HISTORIC PRESERVATION COMMISSION

ALTERATION TO A HISTORIC PROPERTY STAFF REPORT

Site / District(s) 57 Columbus Avenue, William Canavan House (garage and fence), Columbus Avenue -

Case: 2012.117

57 Columbus Avenue Garage

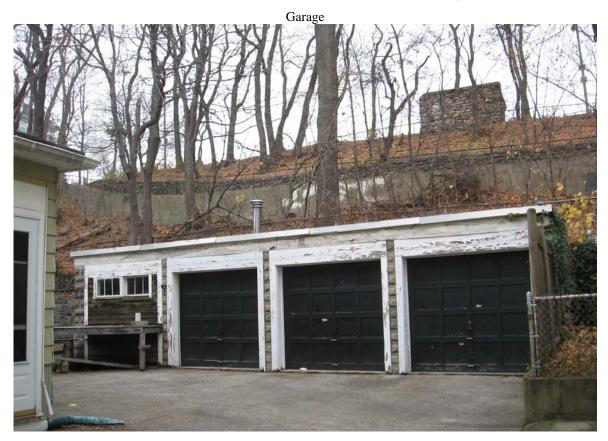
Two bays of the garage are visible from Columbus Avenue at the end of the driveway. The roof of the garage and the fence are visible during the winter and early spring from Prospect Hill Park.

The Columbus Avenue/Warren Avenue Local Historic District is one of the most prominent. Many of the houses on the street have been renovated although there are still several houses in need of repairs and maintenance. A few houses have stables and carriage houses attached but most have neither garage nor stable. Four of the houses in this section of Columbus have concrete block garages constructed in the 1920s. The garage at 57 Columbus Avenue is reported to be in poor condition.
